RxS Additional Conformance Test Signal Proposal

IEEE 802.3dj TF Interim Session

Re: Comments 43, 44

Figure 180-4—Receiver sensitivity (OMA_{outer}), each lane (max)

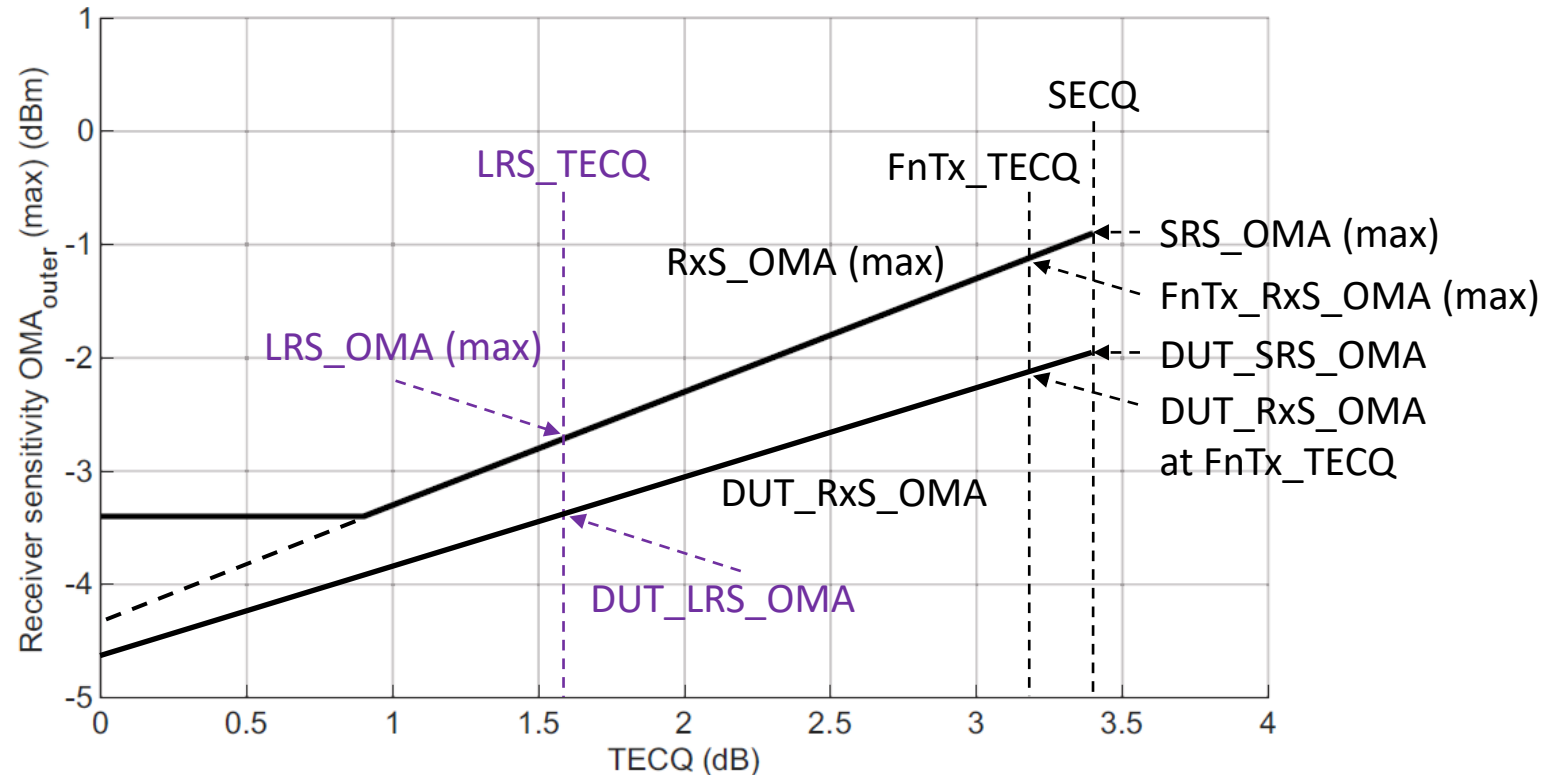
The Low-stressed Receiver Sensitivity (LRS) conformance test signal at TP3 meets the transmit characteristics given in Table 180-7 except for characteristics in Table 180-19.

- Those testing receivers and transmitters may supplement the SRS conformance test signal with functional (worst-case) transmitter(s) (FnTx)
 - It is recommended that such transmitter(s) have their TECQ measured (FnTx_TECQ) so that appropriate OMA (max) limits are used, as illustrated on the previous page.

Table 180-19-Conformance test signal LRS transmit characteristics exceptions to Table 180-7

Parameter	Reference	Value	Unit
TECQ (max)	180.9.8	1.8	dB
TECQ (min)	180.9.8	1.4	dB
Overshoot and undershoot (max)	180.9.10	10	%
Extinction ratio (max)	180.9.12	5.5	dB
Extinction ratio (min)	180.9.12	4.5	dB
Transition time (max)	180.9.13	6.5	ps
Transition time (min)	180.9.13	4.5	ps
ORL tolerance (max)	-	15.5	dB
